# Technical Bulletin

Bulletin No: TCH-002-010

## Subject: **Retrofitting Wide-Based Tires: Increased Vibration Requires Improved Air Chamber Bracket Supports**

**FIGURE 1 - EXAMPLES OF AIR CHAMBER BRACKETS WITH AND WITHOUT GUSSETS**

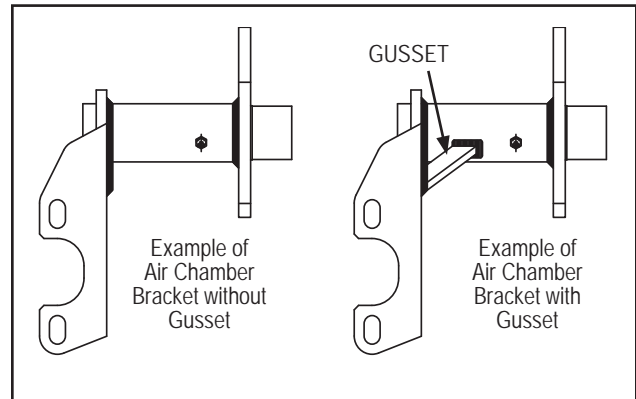
- Air chamber brackets with gussets (see Figure 1). If the air chamber brackets **do not** have gussets, they must be replaced with Bendix approved air chamber brackets **with** gussets. Identify the part number stamped into the support arm (see Figure 2 for location) and refer to BW7253 for the proper gusseted replacement.
- Bendix “Marion” air chamber bracket supports or other Bendix approved air chamber bracket supports, welded to the axle, are required (see Figure 2).

**FIGURE 3 - EXAMPLE OF SUPPORT WELD ARRANGEMENT**

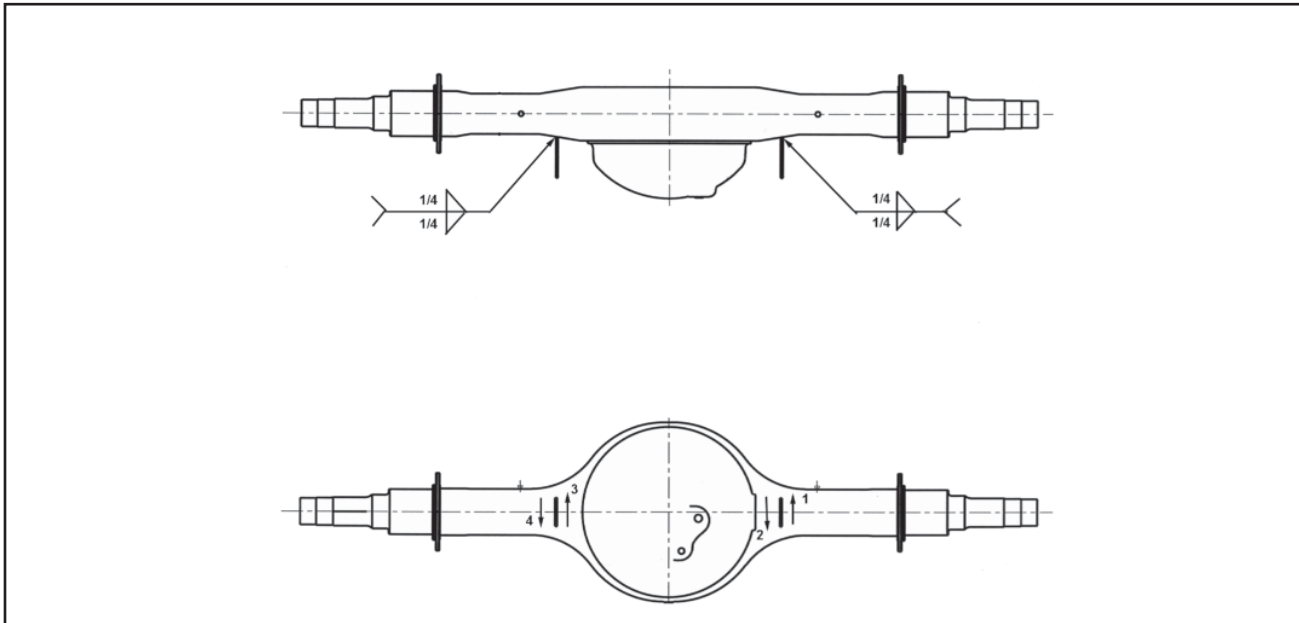
Whenever available, use the axle manufacturer's recommendations for welding the additional "Marion" brackets - the welding notes below are shown for reference only (See Figure 3):

- E70T-5 FCAW or ER70S-6 GMAW Single Pass Process 60°F (15.5°C) Minimum Pre-Heat Temperature
- Maximum Fit up gap of 0.16 inch (4mm)
- The order of welding may be reversed or started on the opposite side
- The direction of welding may be completely reversed
